ADDENDUM NO. 03

Northland Corridor Redevelopment Project Phase 4
631 Northland Ave.
Buffalo, NY 14211

Project No. 432607

Project Northland Corridor Redevelopment Phase 4 (BUDC) Addendum No. 3
631 Northland Avenue, Buffalo, NY Contract -
Wendel Project No. 432607 Date 10/22/25

SITE LAYOUT AND UTILITY PLAN

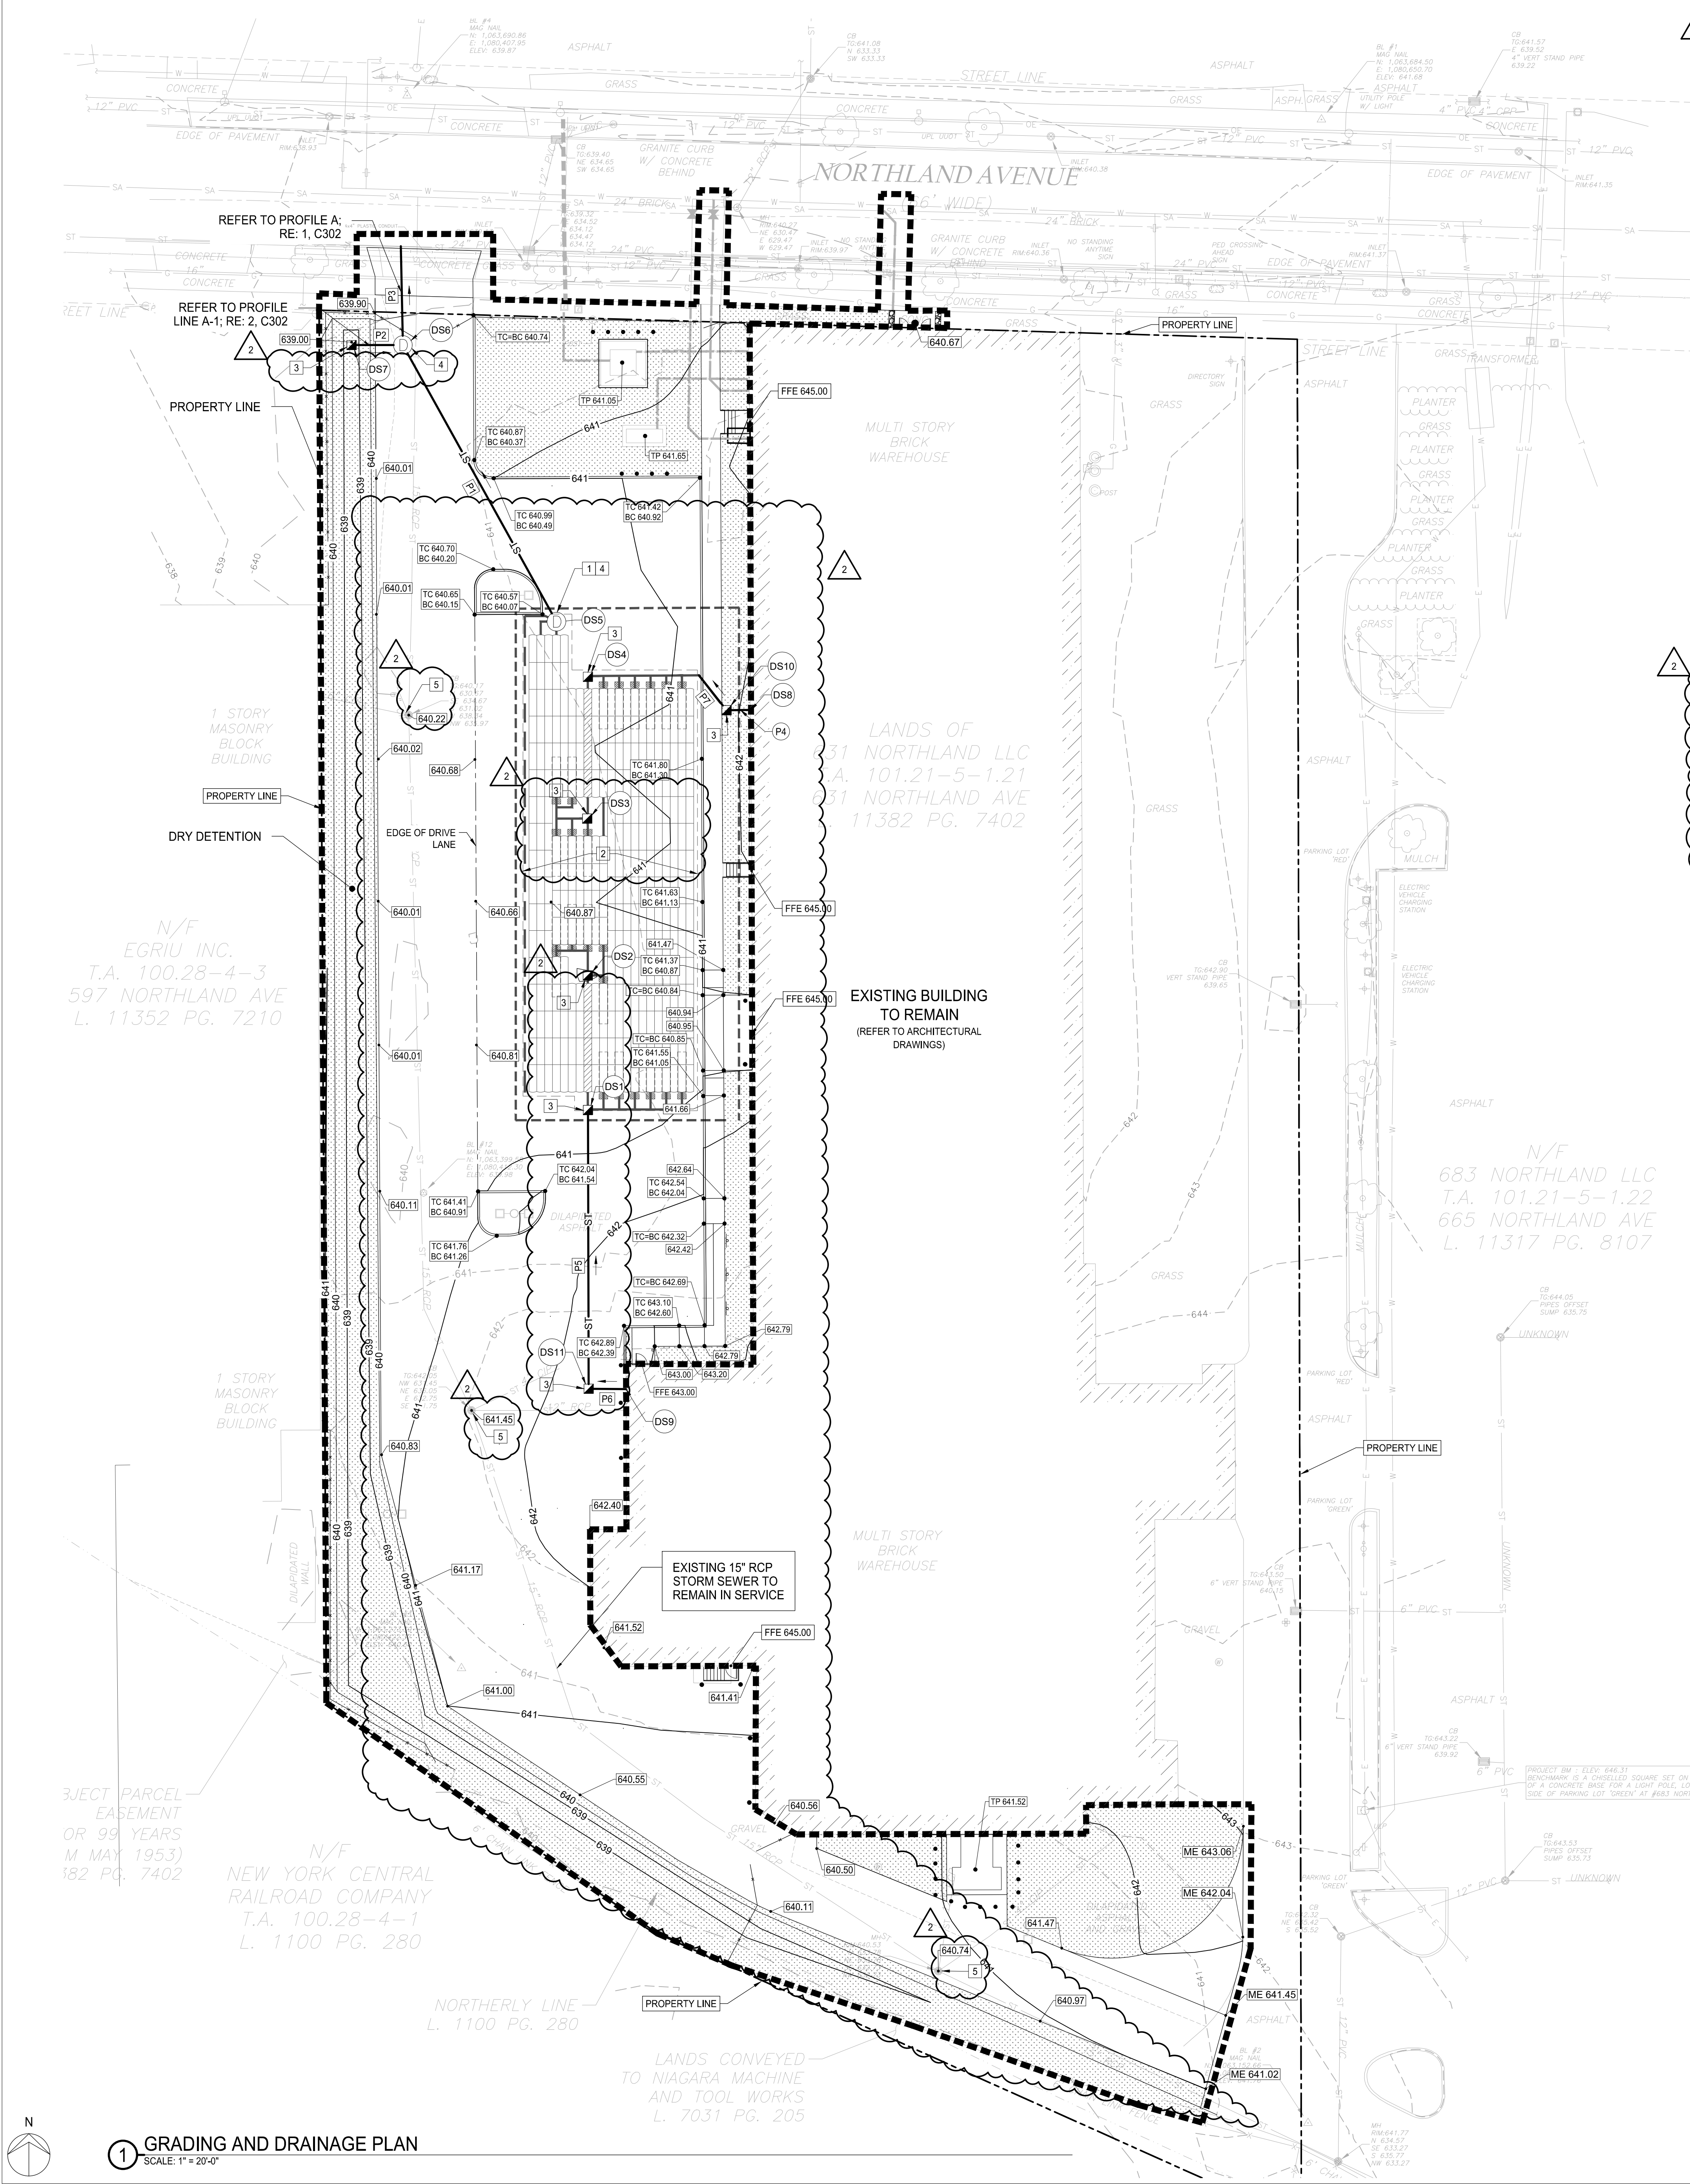
DELETE: Civil drawings C102, C103, C201, C301, C302, C503, C504.

CLARIFICATION: Revisions in the above referenced sheets accommodate environmental requirements and provide clarification to utilities, drainage, and grading.

ADD: Revised civil drawings C102, C103, C201, C301, C302, C503, C504 issued as part of this addendum.
